**Re: 585–649 Mamre Road, Orchard Hills
MOD5 Subdivision of Lot 7 & 9 to Lots 10, 11 & 12
Stormwater Drainage**

We provide this letter in relation to the proposed MOD5 for a subdivision of Lot 7 & 9 into Lots 10, 11 & 12. Specifically this letter reviews and confirms the effect of the proposed subdivision on the as approved and constructed drainage under SSD 7173.

Enclosure 1 - Existing Layout.

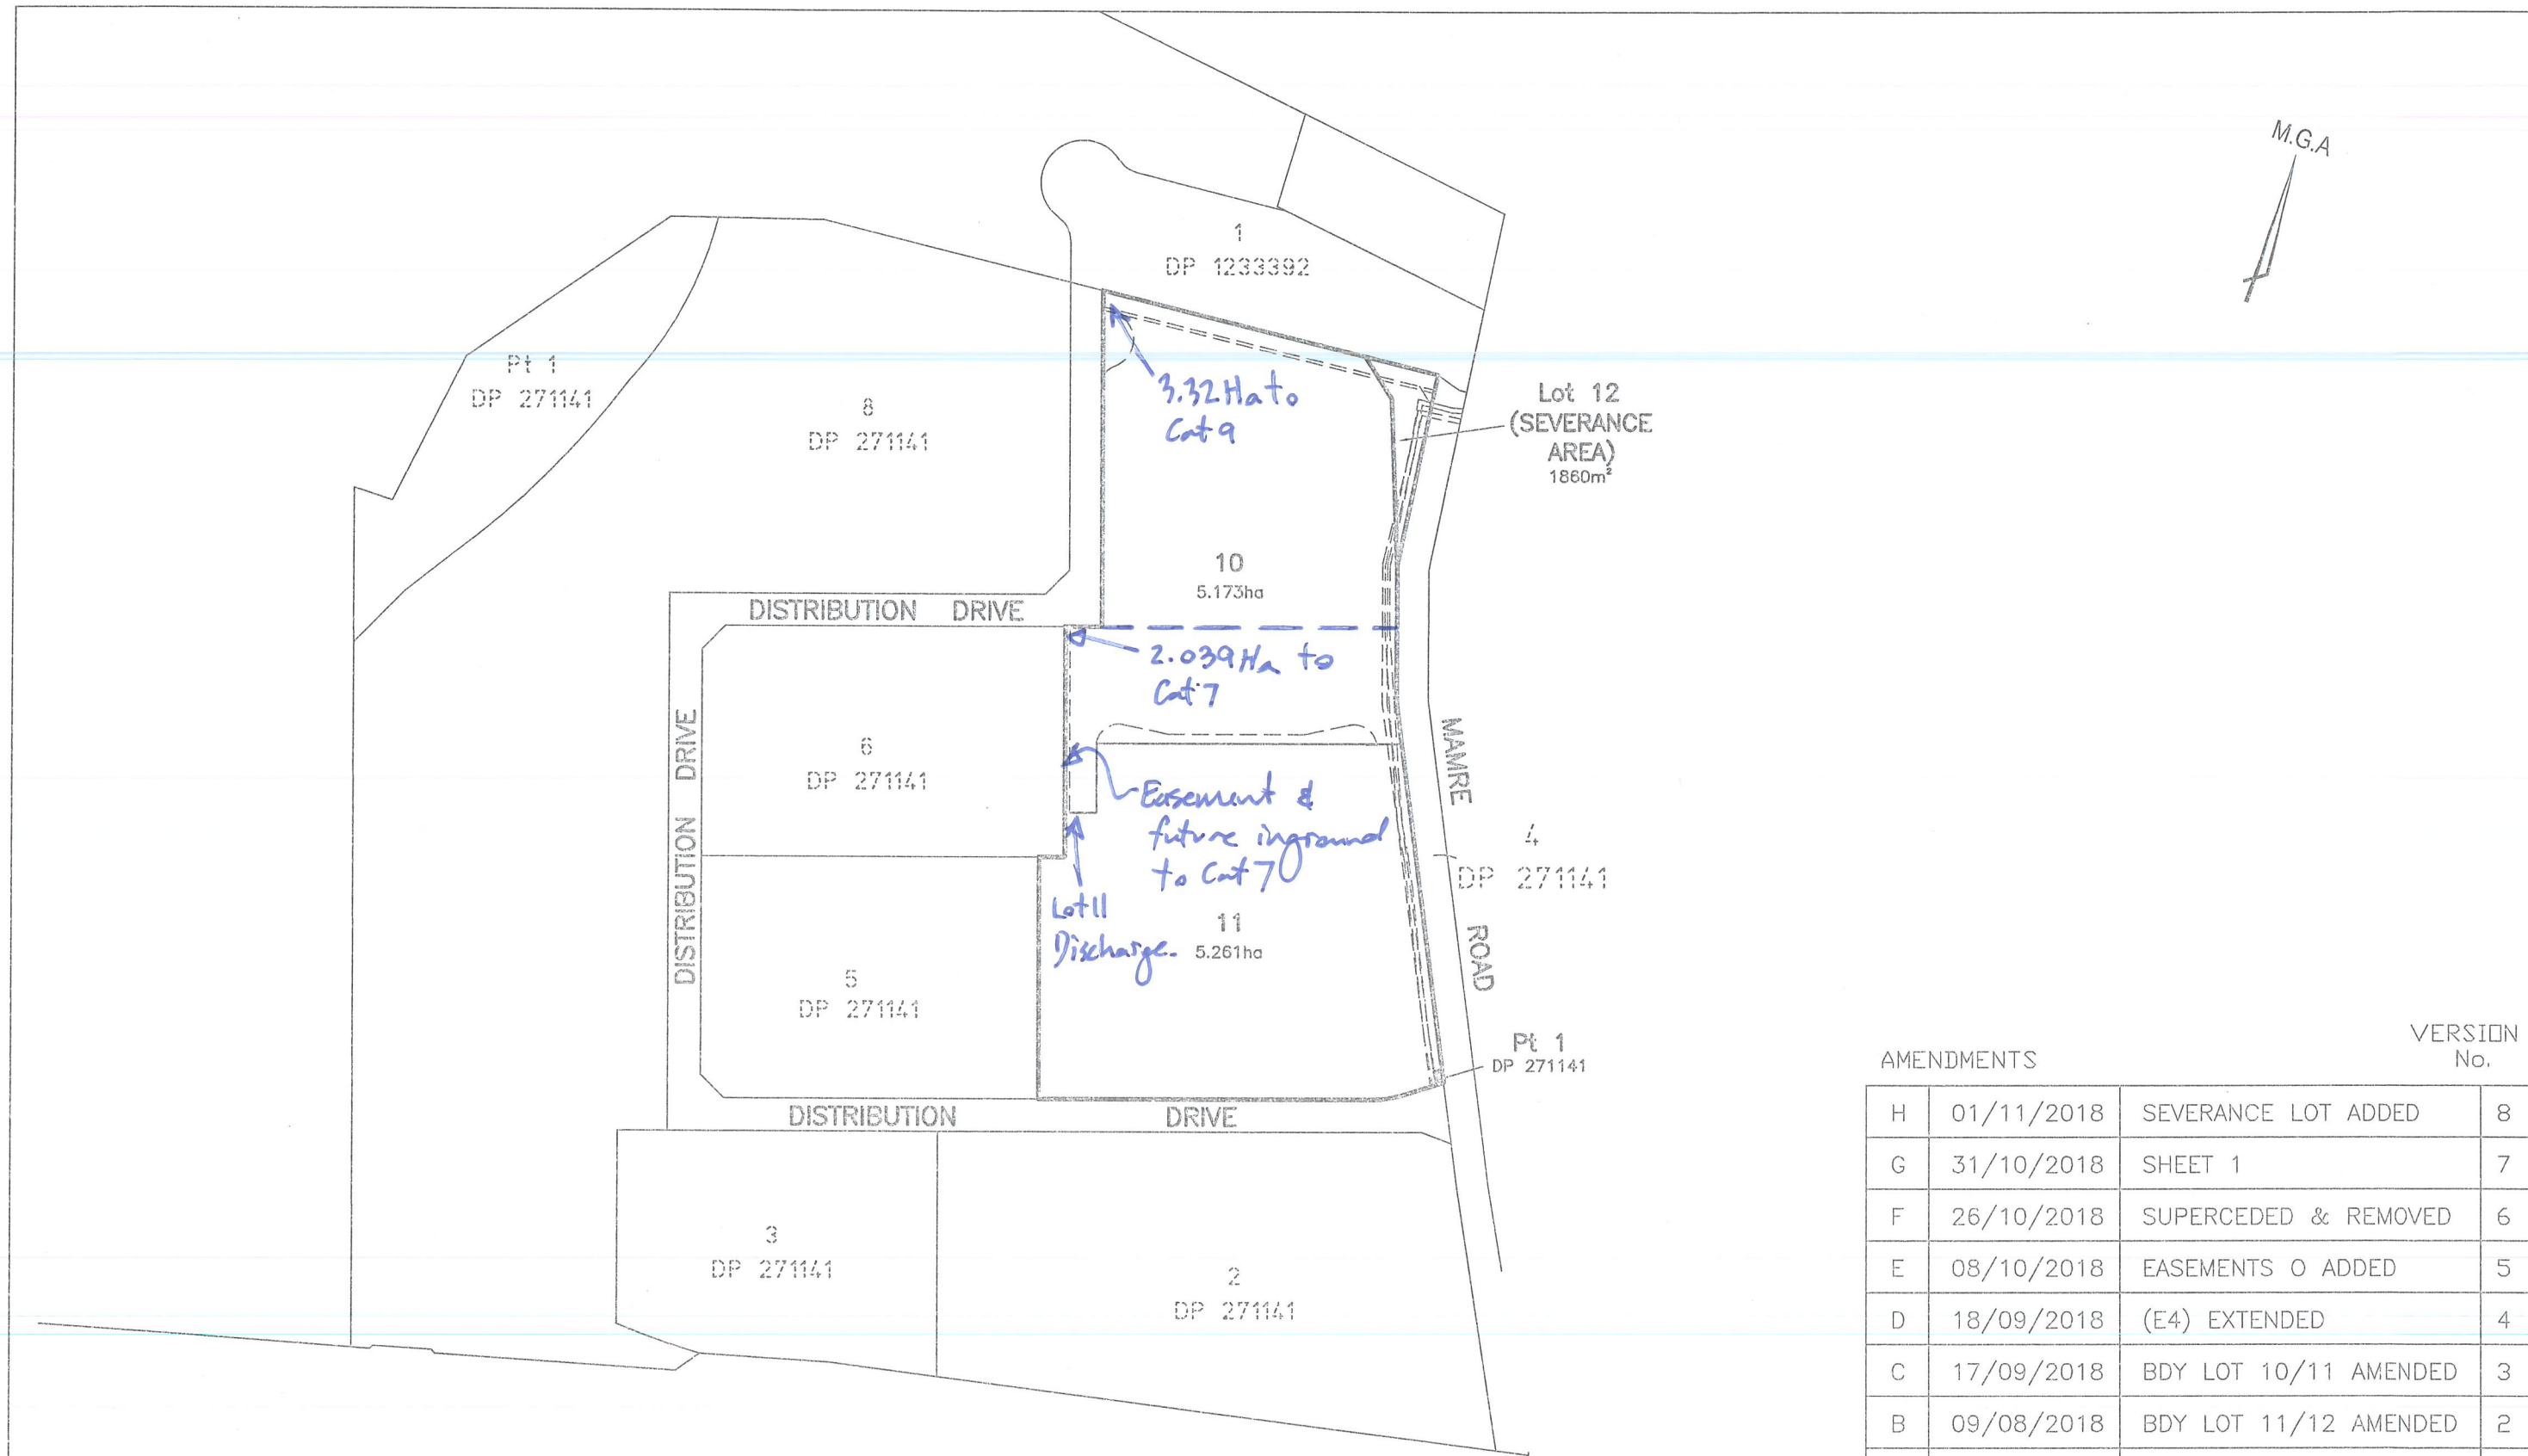
Refer **Enclosure 1** for existing estate subdivision lots, **Enclosure 2a** and **2b** for the proposed subdivision and **Enclosure 3** for the approved drainage catchment layouts.

Enclosure 2a - Proposed Subdivision -

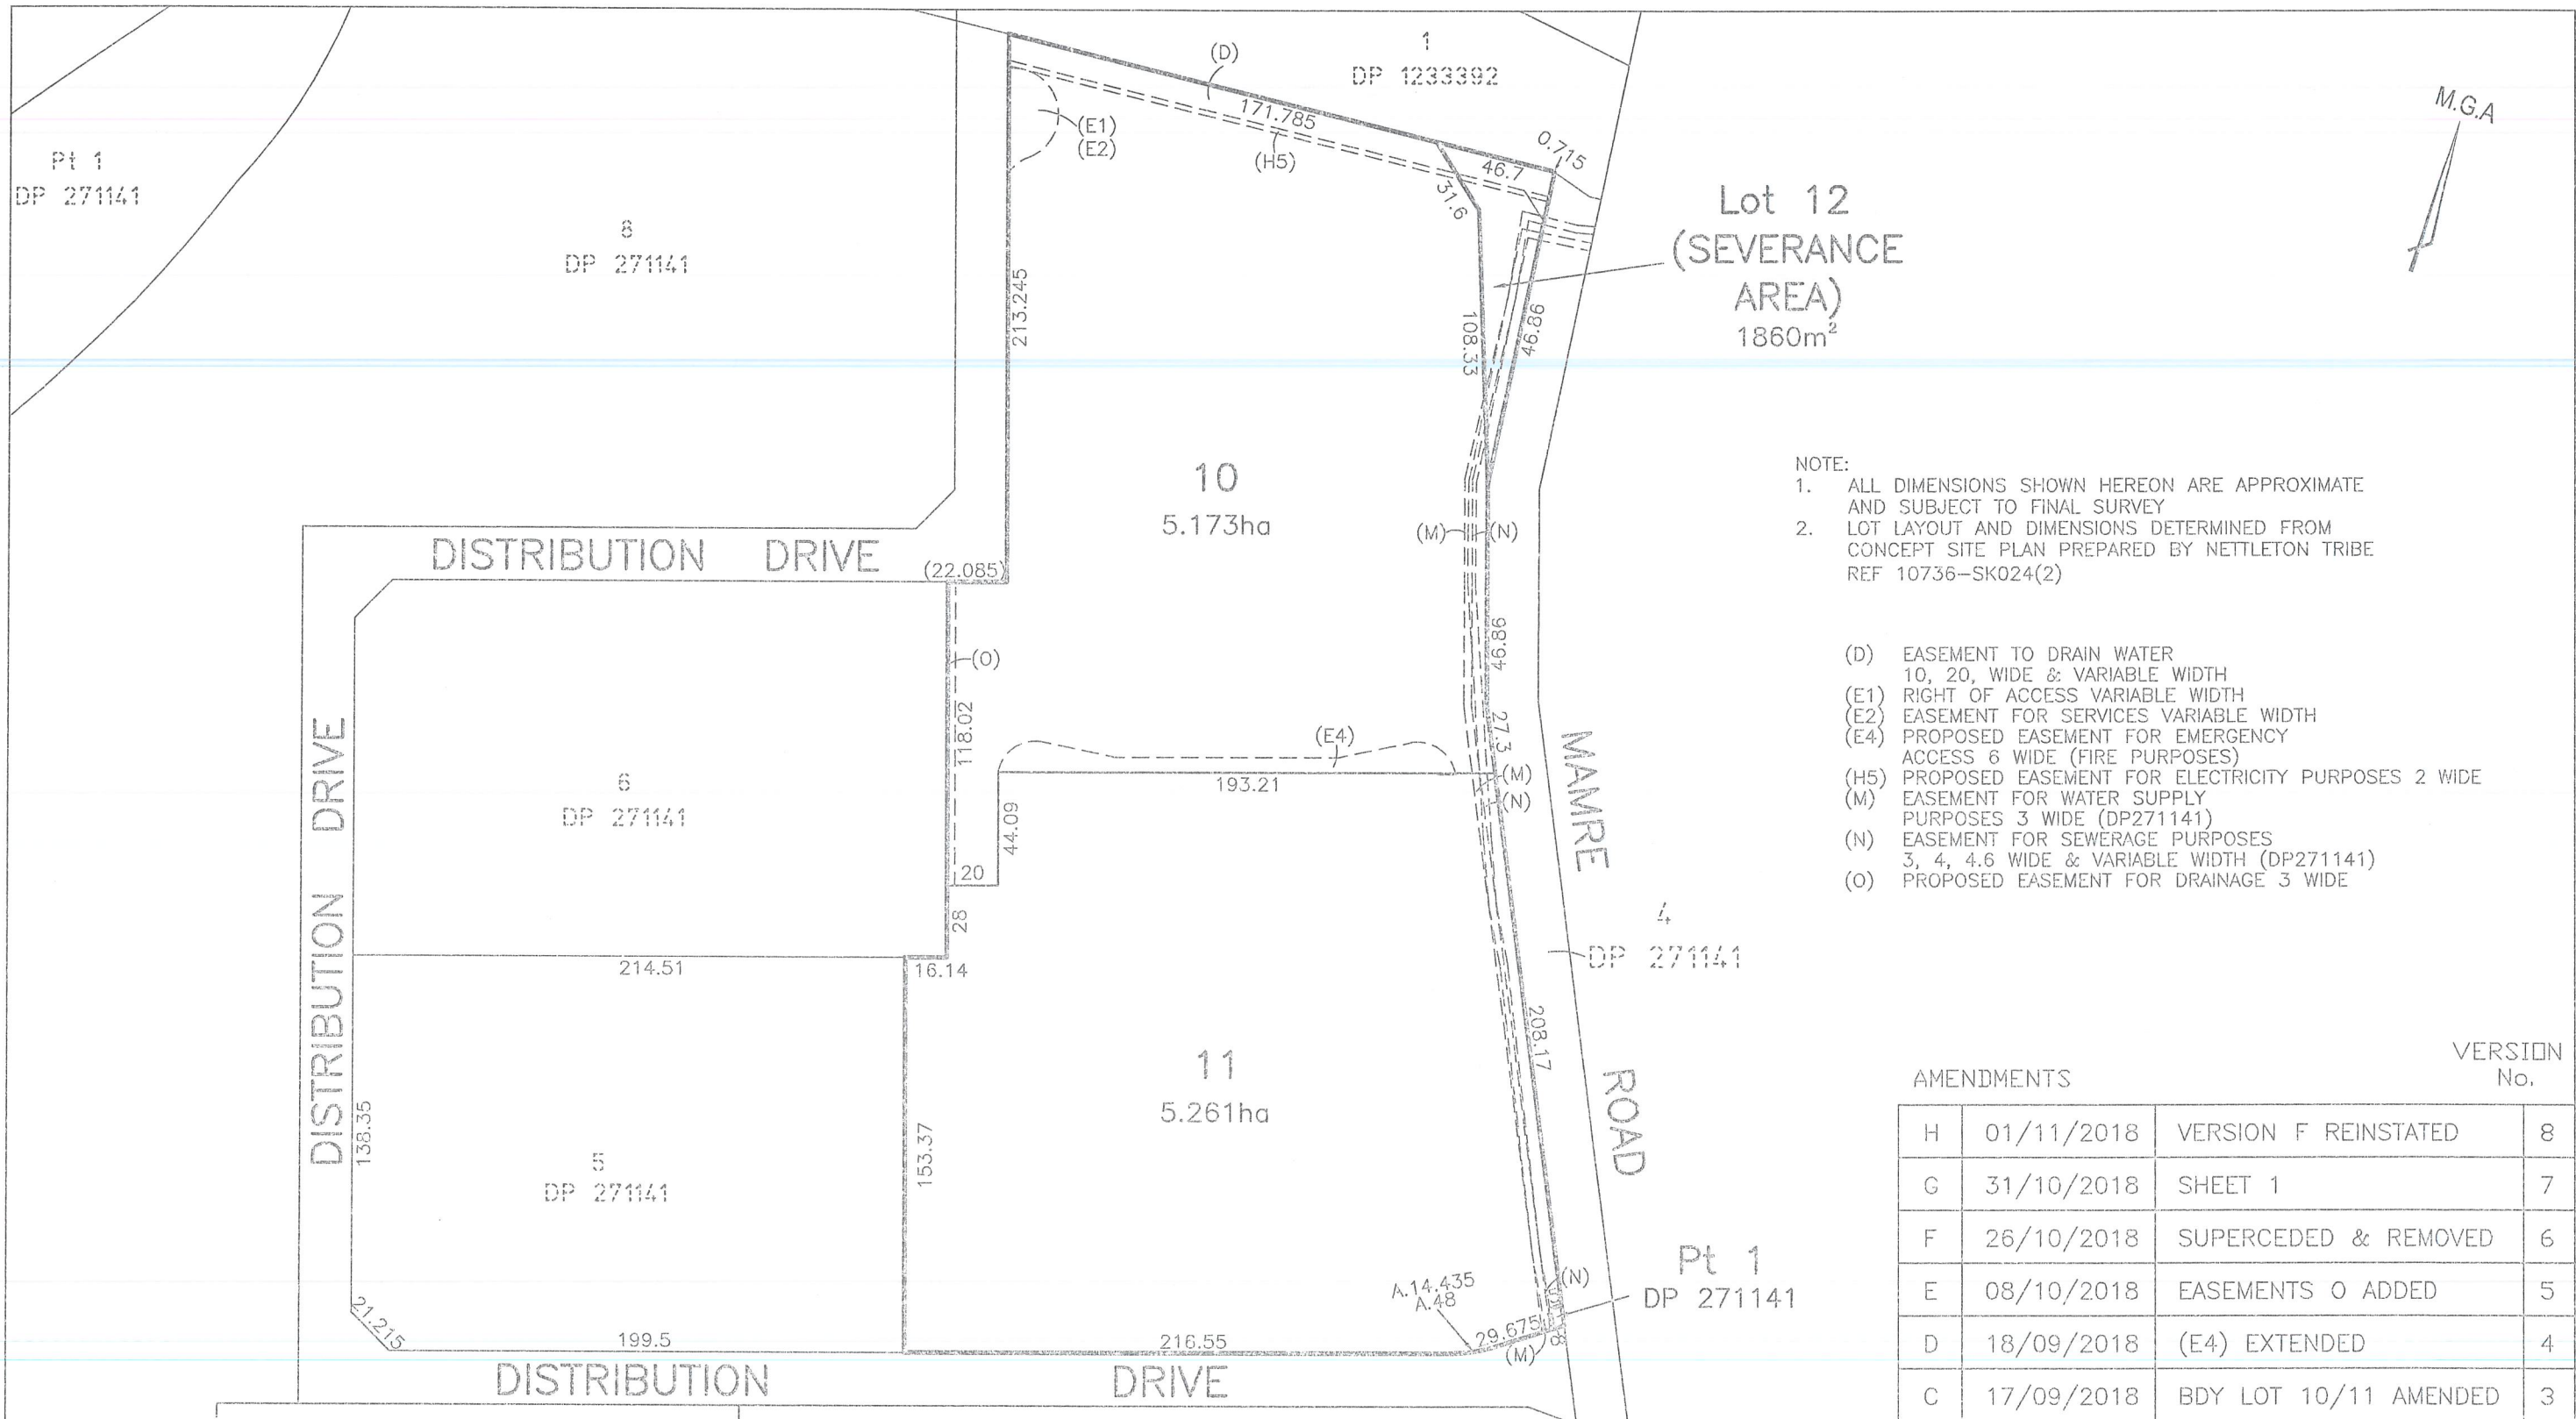
The modification of Lot 7 & 9 into Lots 10, 11 & 12 will require 3.32 Ha of Lot 10 to drain to the Cat9 discharge point located on the north-west corner of Lot 10. The southern 2.039 Ha of Lot 10 and the whole of Lot 11 will be required to discharge to the Cat7 discharge point located on Distribution Drive. An easement (and associated suitably sized in-ground drainage pipe) benefiting Lot 11 through Lot 10 will be required to be provided.

It is noted that a slightly larger overall catchment drains to Cat7 than that in the original SSD 7173 designs. This has been reviewed and confirmed to operate as intended.

Given the above catchment layouts, and associated easements are provided, the proposed subdivision of the land will have negligible effect on the drainage and the system will operated generally as per the approved and constructed SSD7173 designs.
